<b>digital</b>	<b>FIELD SERVICE TECHNICAL MANUAL</b>				Option or Designator
	12 Bit <input checked="" type="checkbox"/>	16 Bit <input checked="" type="checkbox"/>	18 Bit <input checked="" type="checkbox"/>	36 Bit <input checked="" type="checkbox"/>	LT33

Title <b>CONVERTING ASR-33 TO PDP-8/E</b>				Tech Tip Number <b>LT33-TT-1</b>	
All Processor Applicability		Author <b>Sweeney/Quinn</b>		Rev <b>B</b>	
X		Approval <b>E. Purcell</b>		Date <b>7/31/73</b>	
Cross Reference

Converting the ASR-33 to the PDP-8/E

Title ASR CONVERSION 280V, 50Hz V.S. 115V, 60Hz					Tech Tip Number LT33-TT2	
All X			Processor Applicability		Author J. Blundell K. Quinn Rev C	
			Approval D. Staupe		Date 7/10/74	
Cross Reference

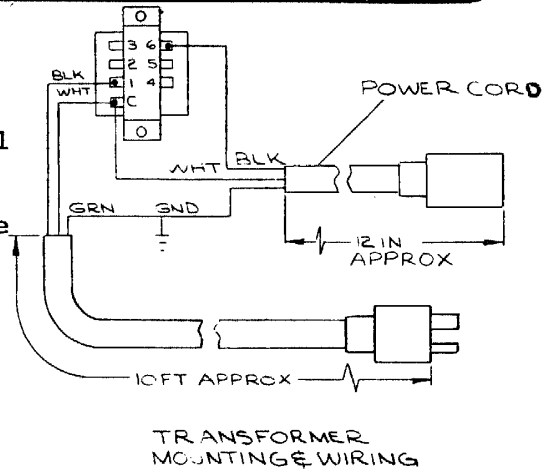
- 1) Disconnect and remove the step down transformer from the teletype base.
- 2) Remove the AC supply lead from the terminal strip inside the teletype.
- 3) Connect the new AC power cord to those same terminals, white to C, black to #1 and green to a chassis screw.
- 4) If the motor is rated for other than desired Hz rating, it must be replaced with one rated for the proper cycle operation. (Not necessary if motor is already 50/60 Hz).
- 5) Change the fuse to correspond to the motor being used.
- 5) Proper operating speed is determined by the ratio of the belt driving gear and its pinion gear: these must be replaced in this conversion.

Part	Vendor Part#		DEC Part#	
	60Hz	50Hz	60Hz	50Hz
Belt driving gear	181420	181855	29-11417	29-11431
Pinion gear	181411	181851	29-11412	29-11428
Motor	181870	182267	29-11432	29-11448
AC power cord	182510		29-16755	
Plug 220V				90-08853
Fuse	MDL 2.25	320246	29-19119	12-11425

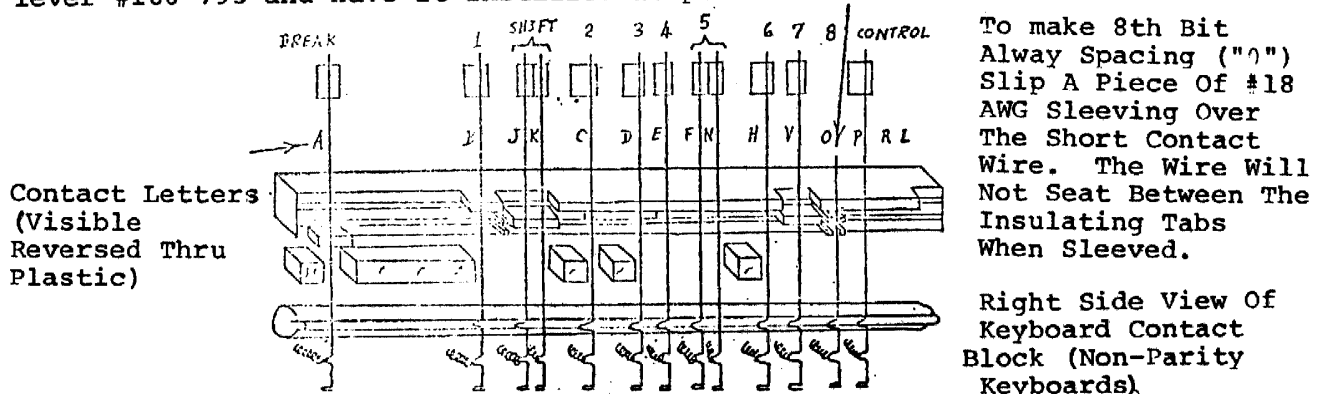
In order to verify that software is not sensitive to the eighth bit ("parity bit") from Teletype it is useful to modify selected Teletypes so that keyboard characters always have their 8th bit spacing ("0") instead of the more usual marking ("1") 8th bit. The simple procedure is detailed on the attached sketch. Machines which are modified should be prominently marked "Modified: Keyboard 8th bit zero."
